SUBJECT: Vectren Proposal

I am writing concerning the proposal by Vectren to build a transmission line from their Indiana location to Big Rivers in Henderson, Kentucky. Because approximately TWO miles of the thirteen mile project cross my farm (Vectren Tracts KY 30 and KY 31, see attached maps) if approved, there are several factors that concern my situation as well as agricultural land in general.

BROWN-REID
 345KV TRANSMISSION LINE
 TAX MAP# 69-6
 FIELD BOOK 1280, PAGE 1278
 MAILING ADD: PO BOX 1821
 HENDERSON, KENTUCKY 42419

KY-30

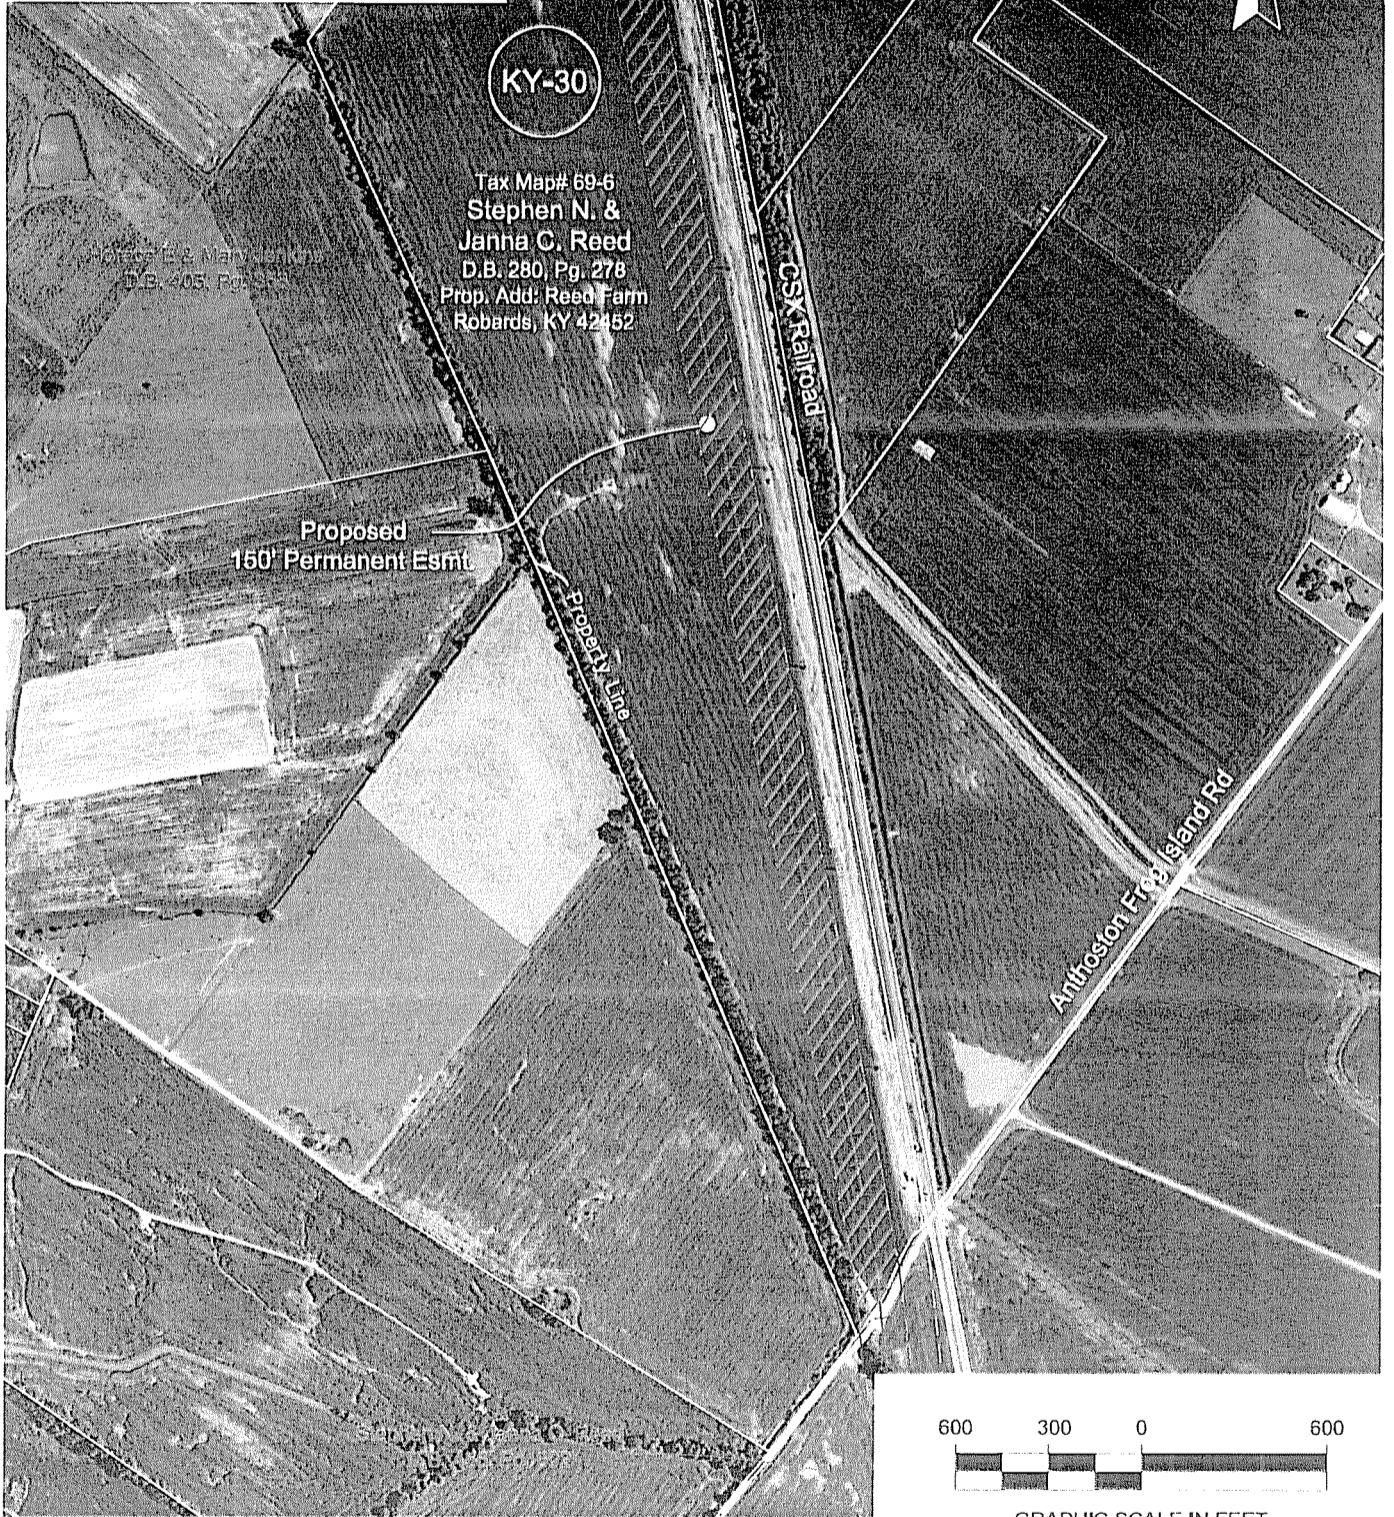
1. DRAINAGE TILE

- If hit during construction, could impact the entire field.
- If mains are damaged, the entire field may have to be retiled at a current rate of \$700 per acre to pattern tile.
- Since damage may not be known immediately, what about a bond by Vectren for future issues?

2. FARMING may be made extremely difficult, if not impossible, on the whole field not just the easement area, depending on

- Size or shape of field
- Placement of Vectren poles in relation to existing power lines, trees, ditches, etc.

4. COMPACTION OF SOIL

- Caused by line installation is not a one year event
- Takes several years for the soil to completely recover from reduced yields

5. What is the ARC distance on a 345KV line?

- Agricultural sprayers are 100 ft. wide, unfold upward and then out.
- What is a safe distance?
